May 6, 2010

**RE: Response to MMD Comments on SAP – La Jara Mesa Project**

**MMD Review of: Revised Sampling & Analysis Plan – Laramide La Jara Mesa Mine**

**FIGURE 1**

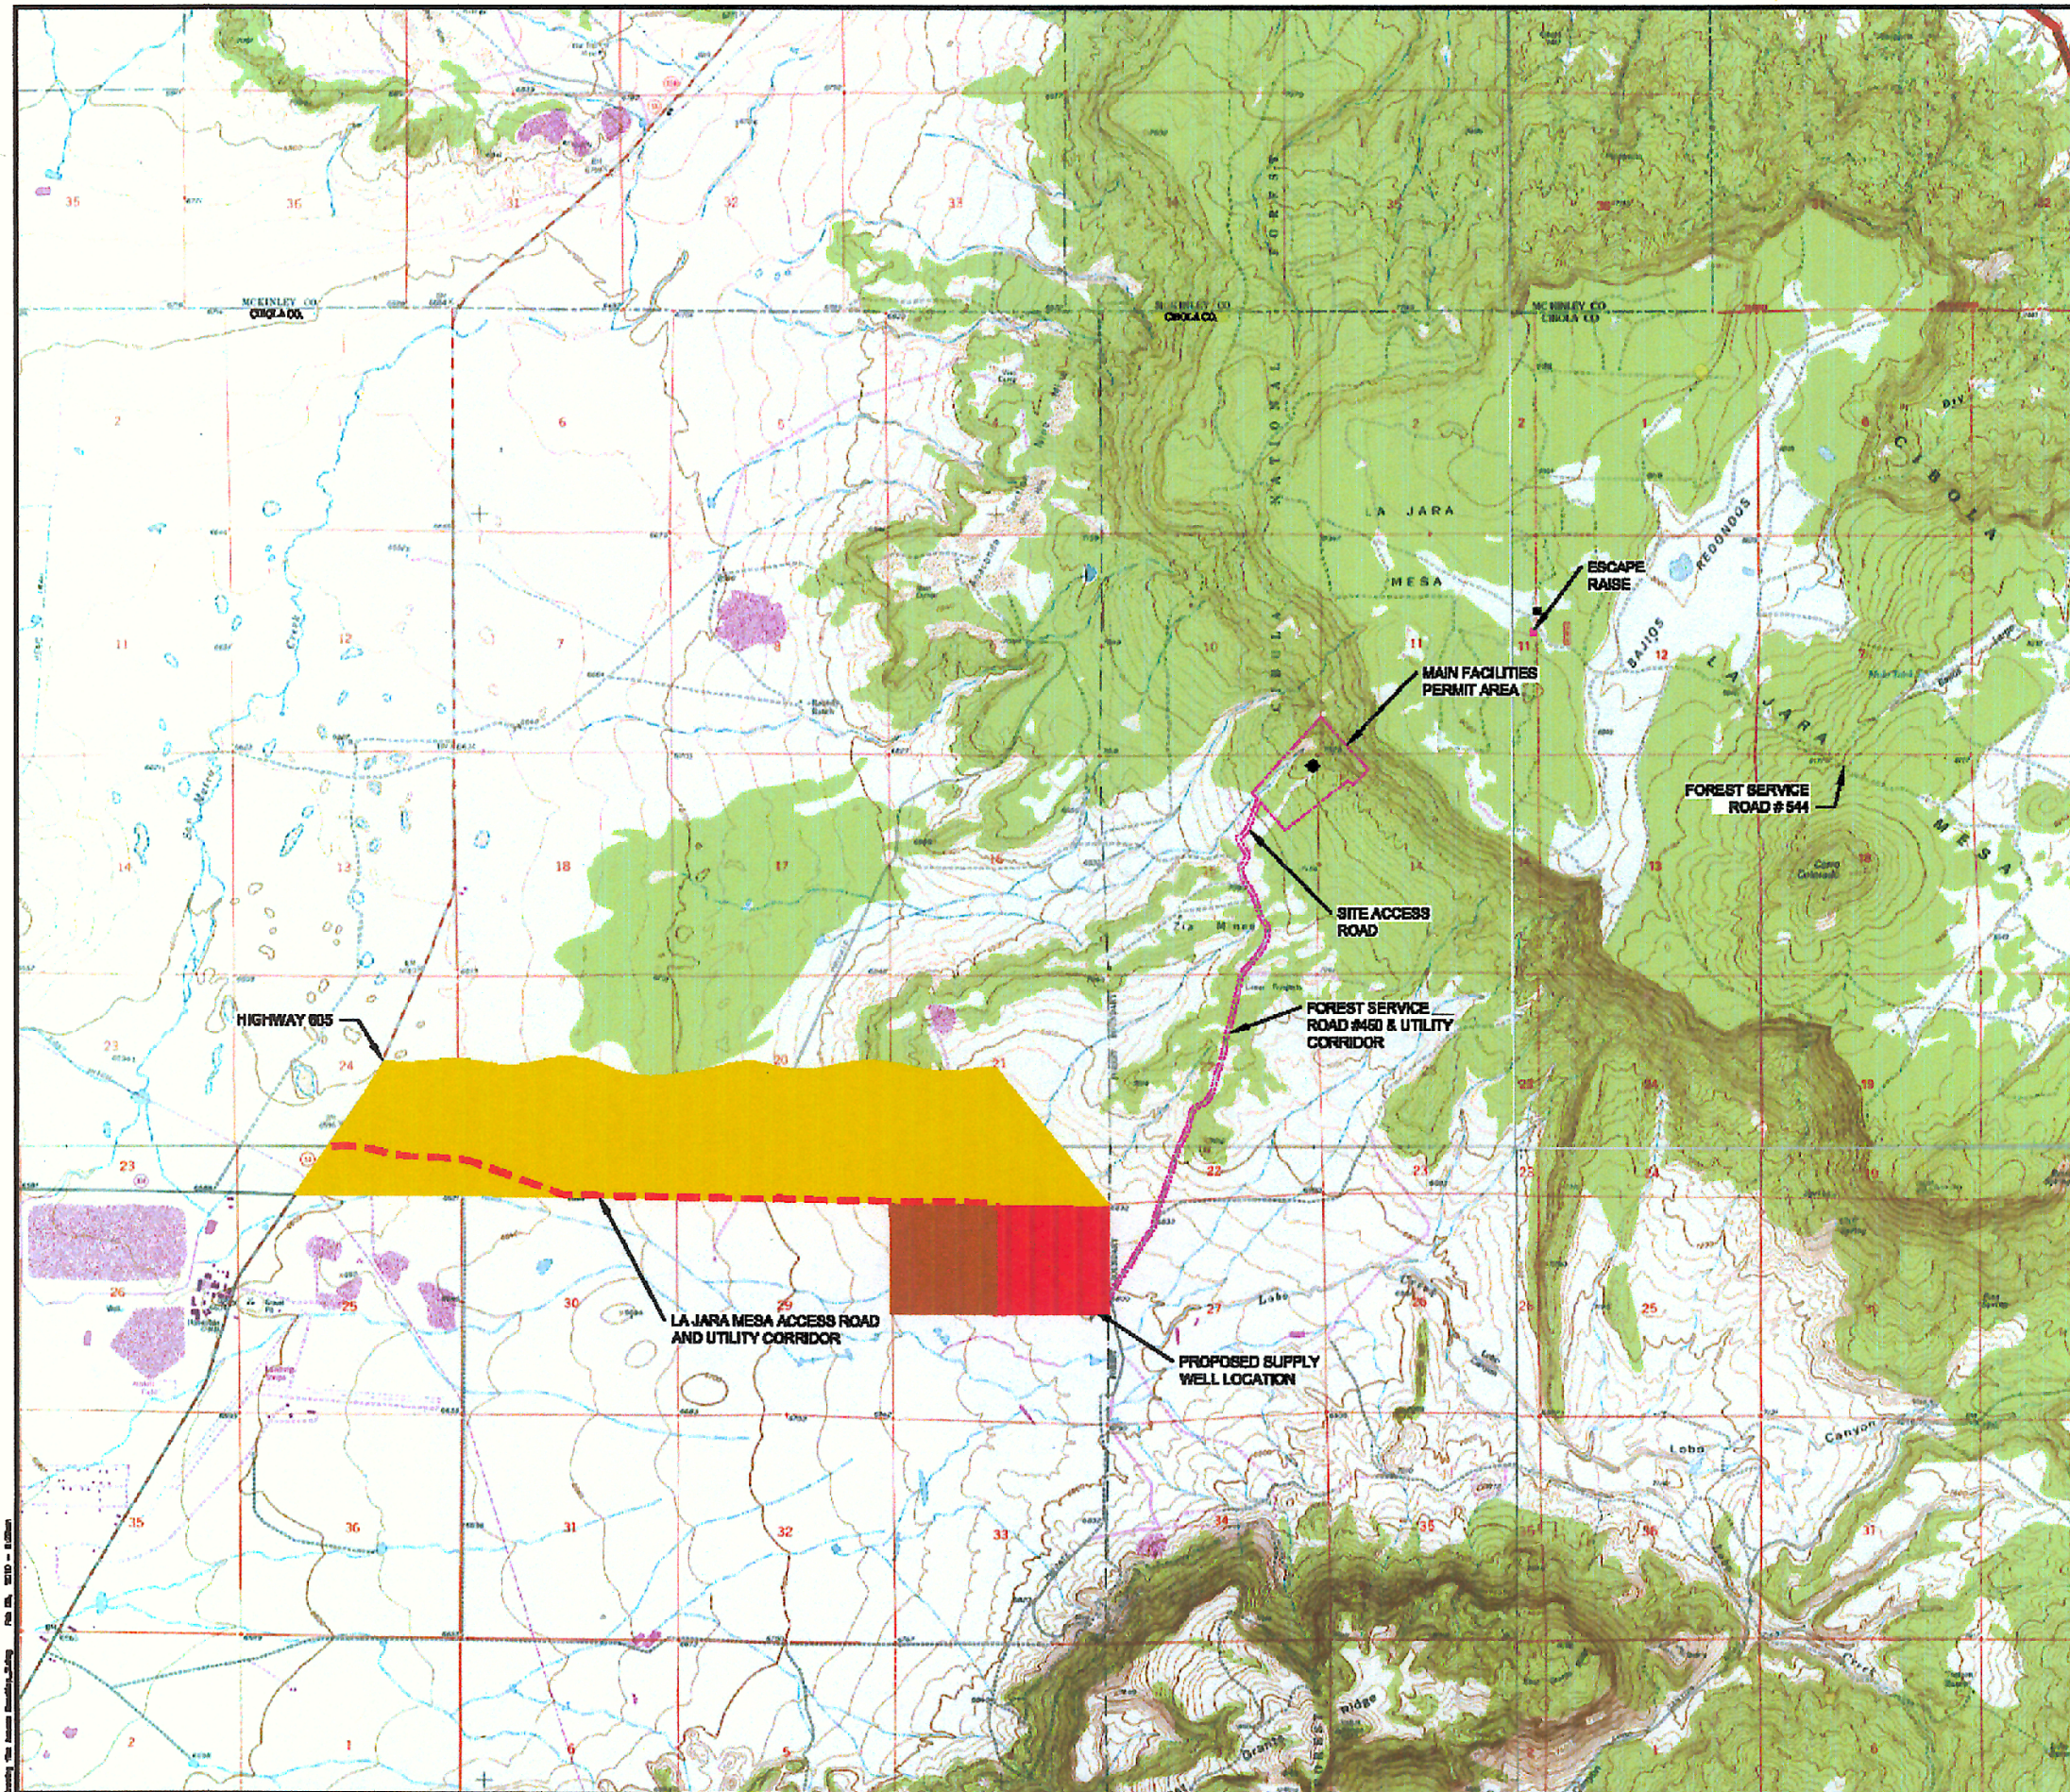
1. Pursuant to 19.10.6.602.D(2) NMAC – Need the required map of all known owners of surface & mineral estates.

Laramide Response: The requested map is provided as Attachment A.
